TECHNICAL BULLETIN

TB 412CF-17-110

**MODEL AFFECTED:** 412CF

**SUBJECT:** HYDRAULIC SYSTEM #1 AND #2 ACCUMULATOR  
P/N 212-076-007-003, REMOVAL OF

**Figure 1**  
Hydraulic System I Pre TB 412CF-17-110 Configuration

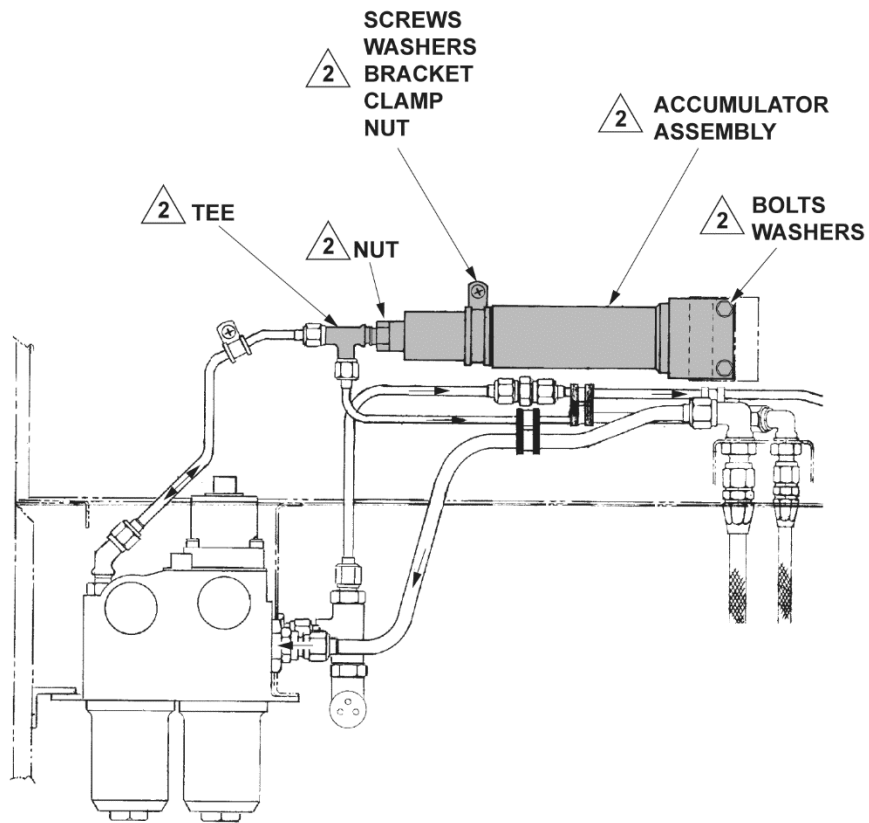
1. Prepare helicopter for maintenance.
2. Gain access to both hydraulic accumulators (C-12-146-000/MF-001).
3. Remove all parts shown in grey on Figure 1 and 2 (C-12-146-000/MF-001).
4. Install Nut plate 90-002-3 shown on Figure 3 as follow:
  - a. Install clamp MS21919WDG4, screw MS27039-1-10, washer NAS1149DO316J with spacer NAS43DD3-12N and nutplate on tube assembly P/N 212-076-571-001. Do not tighten screw at this time to allow proper positioning of nutplate.
  - b. To prevent tube and stiffener preload, temporary install tube to fit and locate the nutplate on stiffener P/N 205-030-845-376 (Detail B) mark position of the nutplate and remove tube assembly.
  - c. Install the nutplate 90-002-3 using rivets MS20470AD4-6 (of the proper length), to the lower left hand stiffener P/N 205-030-845-376.

- 1 Retain parts for relocation.
- 2 Parts no longer required.

**2** Parts no longer required.

**Figure 3**  
Modification

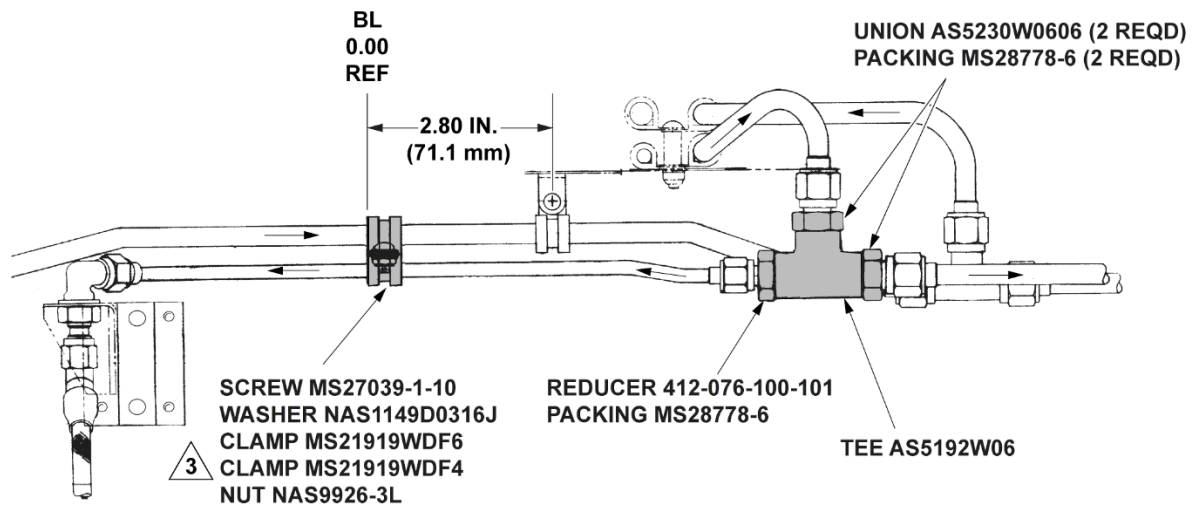
- d. Touch up the area, as required, with primer C-204 (BHT-ALL-SPM).
5. Install new hardware shown in grey on Figure 4 and 5.
6. Make an entry in the helicopter logbook and historical service records indicating compliance with this Technical Bulletin.

3 Relocate clamps and hardware 2.80 inches (71.1 mm) away from center of bracket.
